ADDENDUM - 1

ADDENDUM TO BOILER SPECIFICATION
(BOTTOM ASH HOPPER)

MAHARASHTRA STATE POWER GENERATION CO. LTD.	VOLUME - VI
	KORADI THERMAL POWER STATION 2X660 MW UNITS - 11 & 12 PROJECT	-
	RFx No. 3000046202 (BTG Package)	ADDENDUM - 1
	ADDENDUM TO BOILER SPECIFICATION (BOTTOM ASH HOPPER)	REV. - 0

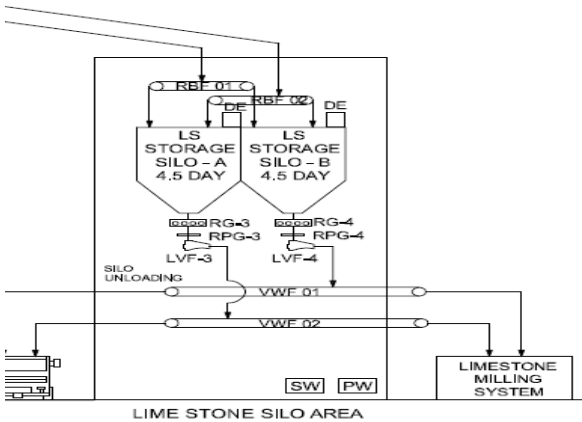
132	VOLUME - III	PART - A / SECTION - 4		3.42.04	Each water storage tank shall be designed to store 2 Hrs (min.) water requirement of the FGD system.	Bidder considers 15 minutes storage capacity for process water tank as per industry practice. Please confirm.	Bid Specification Prevails
133	VOLUME - III	PART - A / SECTION - 4		3.42.07	2x100% Mist Eliminator Wash Water Pump for each unit connected to each of the Process water Storage tanks along with all necessary piping, valves, control & instrumentation shall be provided by the Bidder. Each pump shall cater to maximum mist washing requirement of one unit. The capacity of the pumps shall be such that the total capacity of working pumps is sufficient to meet the maximum wash water requirements of mist eliminators of the absorber. A further 10% margin shall be provided over the above capacity for all the above pumps.	ME wash water pumps are not applicable as per QFGDM standard design. The water required for ME wash shall be supplied by process water pump itself. Hence Bidder does not envisage separate ME wash water pumps.	Can be accepted for JBR technology only

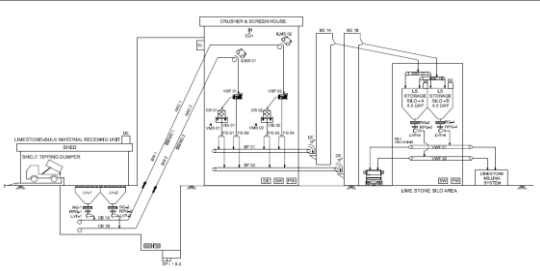
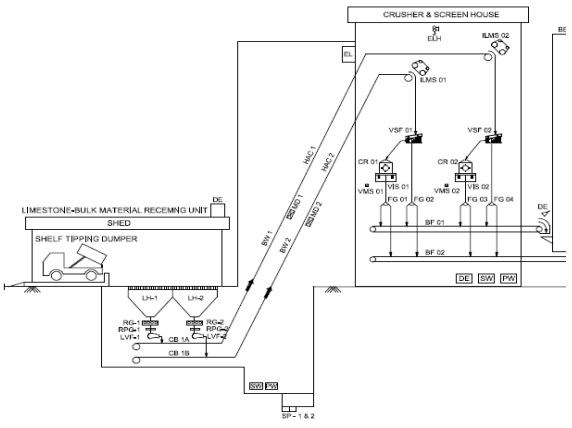
179	VOLUME - III, PART – A, SECTION - 4	TECHNICAL SPECIFICATION FGD, LIME HANDLING & CHIMNEY		6.03.00, Page no 81	6.03.00 Crusher 9. Type of Drive Through Gear box, V-belts, sheaves	As per the standard practice, V-belt drive is provided in hammer crusher for all ongoing NTPC/DVC projects and gearbox is not applicable. Bidder is considering the same arrangement for this project also, where gearbox is not applicable.	Noted
180	VOLUME - III, PART – A, SECTION - 4	TECHNICAL SPECIFICATION FGD, LIME HANDLING & CHIMNEY		6.03.00, Page no 81	6.03.00 Crusher c) Liner plate SS-409	In all ongoing projects Mn steel Housing liner is provided for hammer crusher for Limestone application. Bidder requested owner to allow to select MOC of crusher as per OEM recommendation.	Noted
181	VOLUME - III, PART – A, SECTION - 4	TECHNICAL SPECIFICATION FGD, LIME HANDLING & CHIMNEY		6.03.00, Page no 82	Belt shall be of Nylon-Nylon. The cover shall be Fire resistant grade type (BS 490 Part-I grade N17 rubber). Fire resistant property shall conform to Canadian Bureau of Mines Report No. FRL –269.	There is a discrepancy in the said clause for consideration of belt grade. Based on our earlier experience in FGD Project, Bidder shall consider belt confirming as per IS 1891 , Confirming FR properties of as per ISO-340 & CAN/CSA/M-422-M87 Grade-C. Please confirm specification of belt to be considered.	Bid Specification Prevails

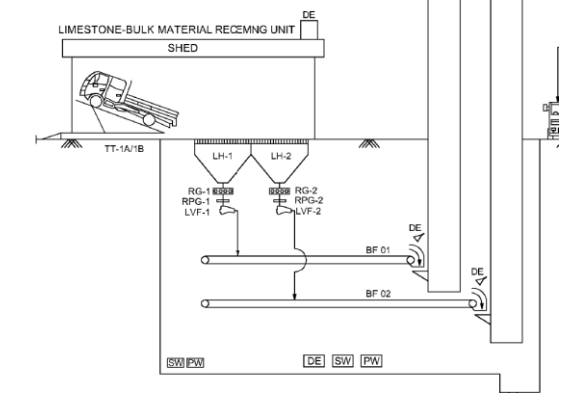
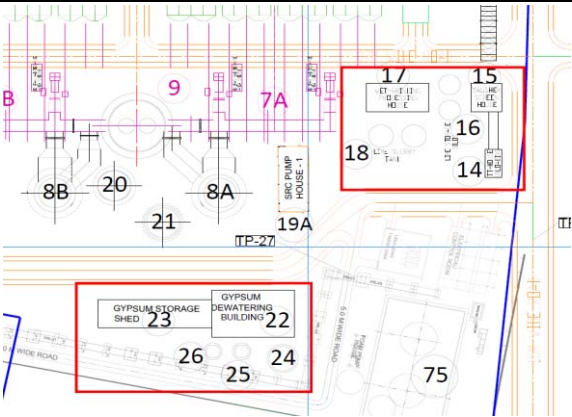
203	VOLUME - III, PART – A, SECTION - 4	TECHNICAL SPECIFICATION FGD, LIME HANDLING SYSTEM & CHIMNEY		6.04.00, Page no 82	14. Bucket elevator conveyor speed M/s Maximum 0.6	Bucket elevator design shall be inline with IS 7167, IS 12941,IS 7054 and other relevant Design standards of bucket elevator. As per all ongoing NTPC & DVC projects bucket elevator speed remains up to 1.5 m/s. Bidder requested owner to allow to decide bucket elevator design parameters as per OEM recommendation and as per relevant design standard.	Bid Specification Prevails
